Agency Review Comments

Project Name Falcon Highland Sketch Plan Amendment
Applicant Matrix Design Group, Inc.
EA Number EA2116
File Number SKP214
Project Manager Kari Parsons (kariparsons@elpasoco.com)
 (719) 520-6306
Status Active
Created 2/12/2021 9:58:05 AM

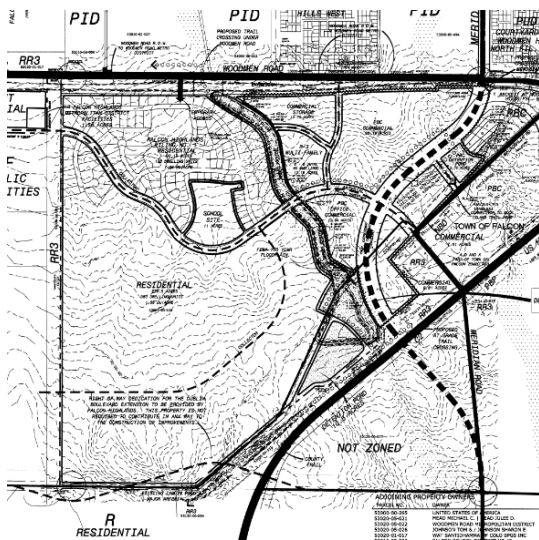
53000-00-568,
 53000-00-567,
 53000-00-568

correct parcels please
 update application
 also please

RESPONSE: The parcels number are correct per the EPC Assessor website. There are no parcels with the numbers indicated in the comments as part of this Sketch Plan.

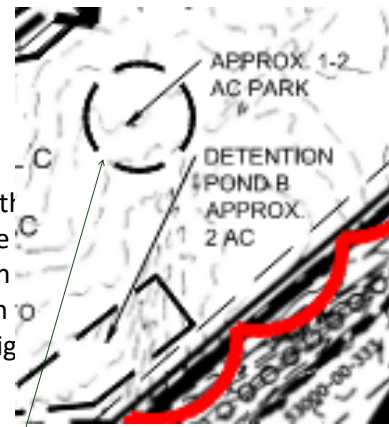
carry over comment- clarify :Is there is a reduction in open space from the current PUD and SK or is it staying the same in this amendment? Or is it decreasing...state justification or rational

Response to the question?

RESPONSE: This sections updated as requested. meet the need for the proposed development and h Plan approval.
